Date: March, 2021

Corrective Action ID: AX068/20/S

Customer Safety Information (CSI) for Field Safety Corrective Action

Subject: Addendum of the tooth belt cleaning for AXIOM Artis, Artis zee, Artis Q and Artis Q.zen

Examples of belts

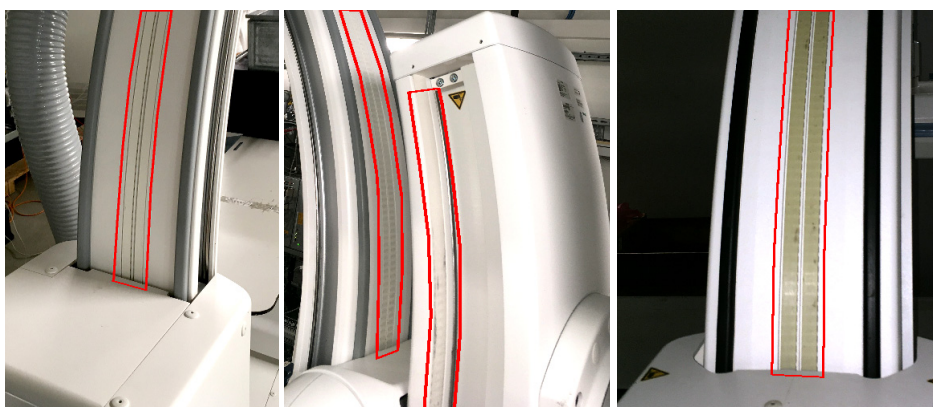
Safety information - cleaning units which have a visible belt

Pay special attention when cleaning units (stands) which are equipped with a visible belt.

Observe the following information for cleaning:

- Do *not* use cleaning agents containing *aldehydes*.
- Do *not* use *spray bottles*.
- Perform *dry* cleaning, if possible.
- Use *little* cleaning agent or only water, if possible.
- ◆ *Wipe dry*.
